工程指示 / 要求簡箋(E.I.)

工程指示編號：EI/ 03/0 /19 修改版次：
 工程編號：J836 工程名稱：日出康城 7 期 (平台)
 工程項目：skylight 補回鋁板 2 件
 收件人：生統 發件人：Joe Chan 日期：15/3/2019

名稱	鋁板加工圖	制圖	曾建平	2018-11-20	修改			
材料	3mm厚鋁板	復核			日期			
顏色	UCT802787XL-3淺灰色	批准			圖號	J836-SK-LB66

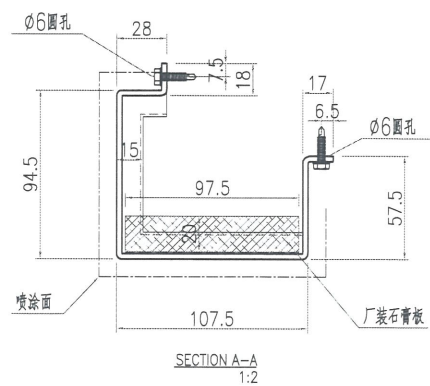
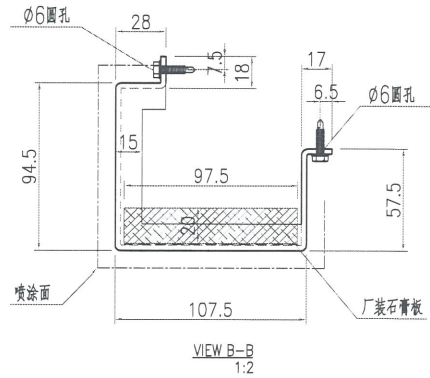
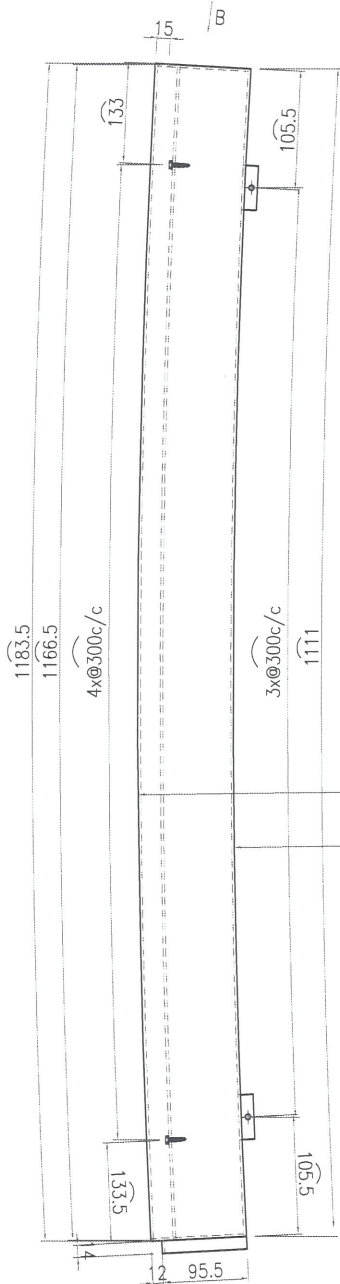
內容：鋁板 J836-SK-LB66 總數是 4 件，因加工圖錯誤標示為 2 件，因此做少 2 件。請依附件資料，生產鋁板 J836-SK-LB66 2 件
